Kelvin Henderson
Vice President
Catawba Nuclear Station

Subject: Fifth Six-Month Status Report in Response to March 12, 2012 Commission Order
Modifying Licenses With Regard to Requirements for Mitigation Strategies for
Beyond-Design-Basis External Events (Order Number EA-12-049)

FIFTH SIX MONTH STATUS REPORT (ORDER EA-12-049)

CATAWBA NUCLEAR STATION (CNS), UNITS 1 AND 2

Portable Pump Location at Ultimate Heat Sink

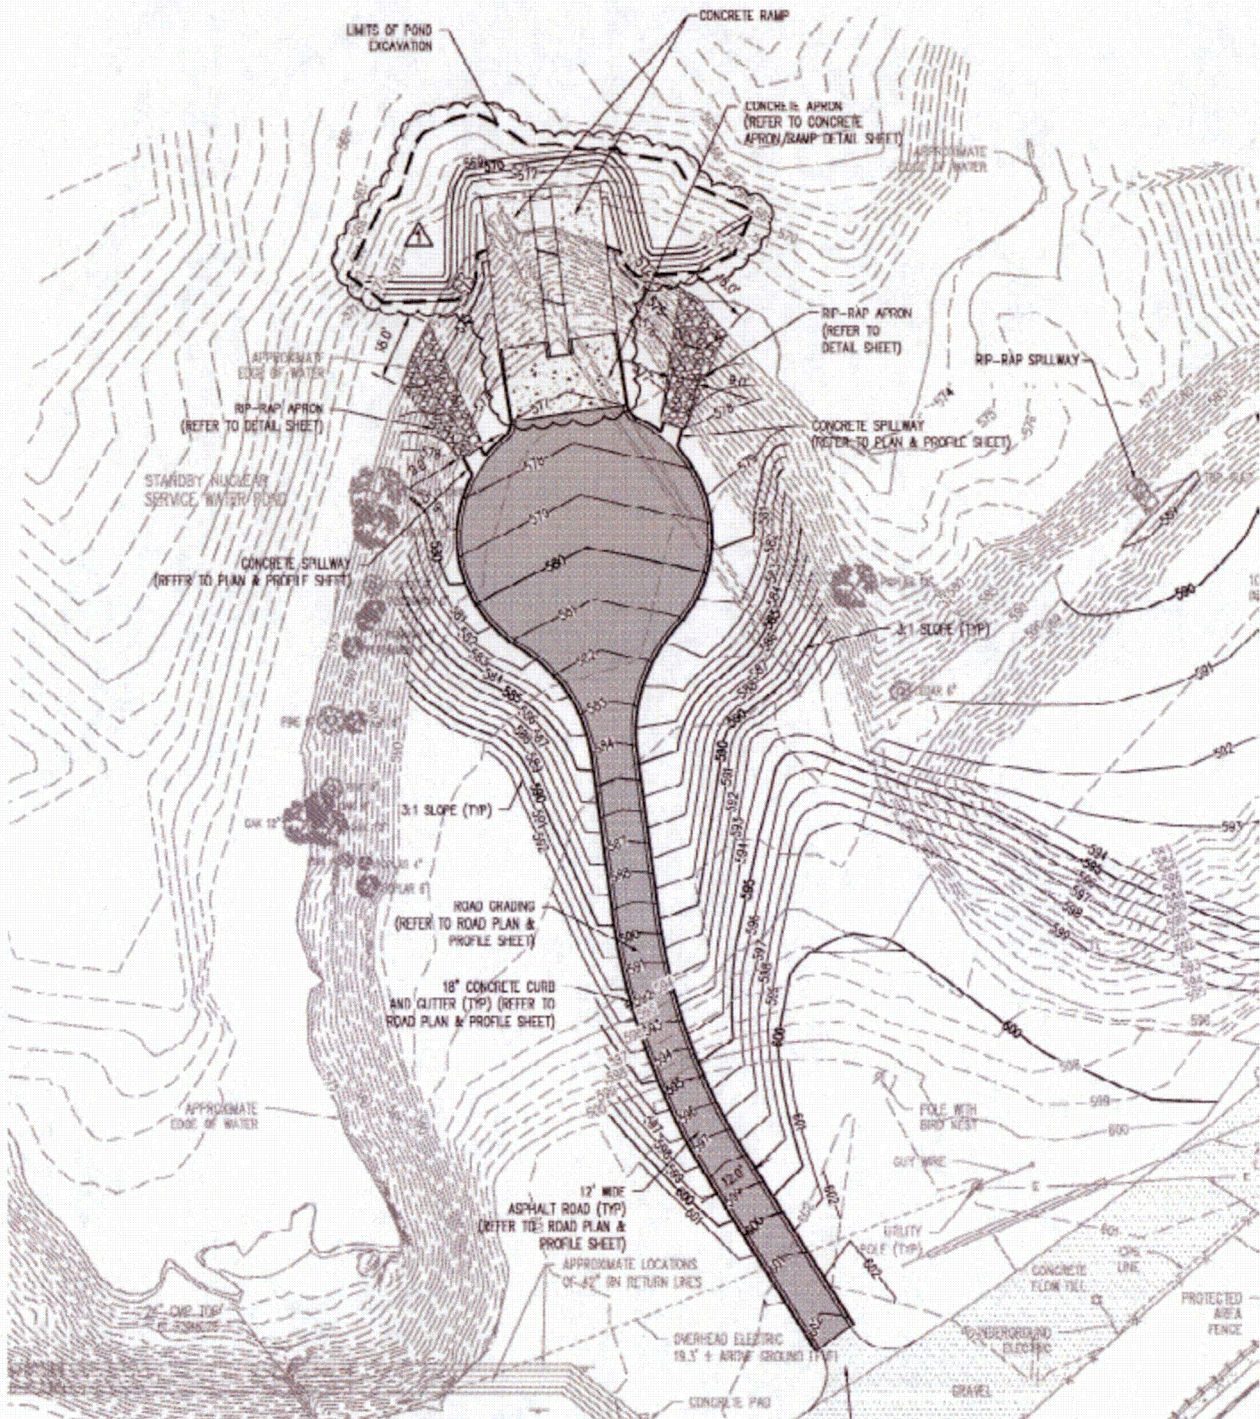
- 5) Change: The sketch of the Portable Pump Location at Ultimate Heat Sink on Page 78 of 94 in the OIP has been revised based on a change in the design.

Justification: The design of the Standby Nuclear Service Water Pond (SNSWP, aka Ultimate Heat Sink) Portable Pump access structure was revised from a sea wall type design to a boat ramp type design. The revised sketch shows the final as built configuration.

Documentation: Reference EC110731.
